# **PRODUCT CHANGE NOTICE**

**Product Improvement –Design  
Change for the Listed Intersil  
Products**

**Refer to:  
PCN14062**

**Date: December 19, 2014**

# PCN14062 – Appendix I

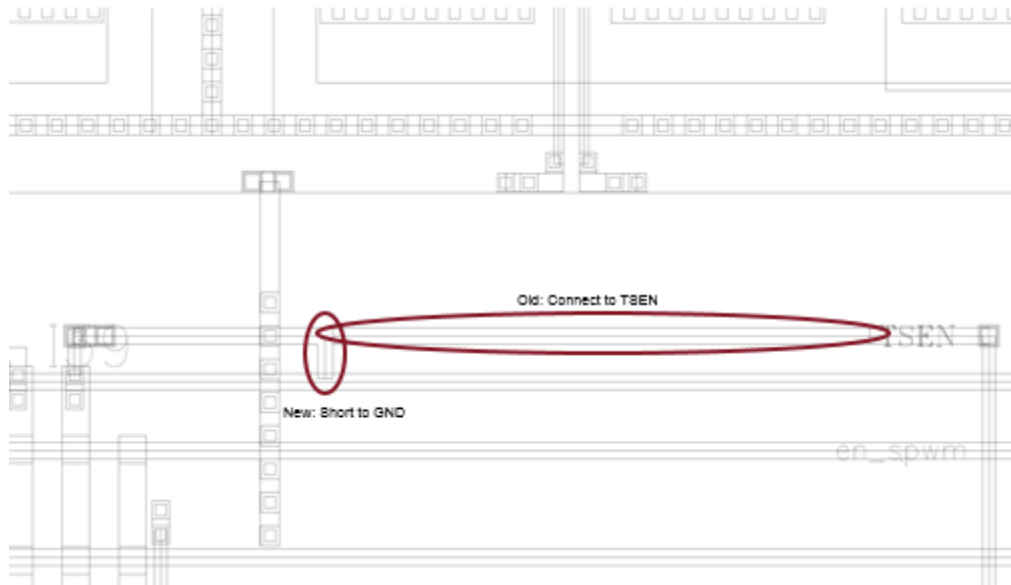
Schematic change, one cut / metal routing where a 3 input NOR Gate was changed from TSEN to GND, this re-routing requires one simple one layer metal edit. Design validation and simulation runs complete.
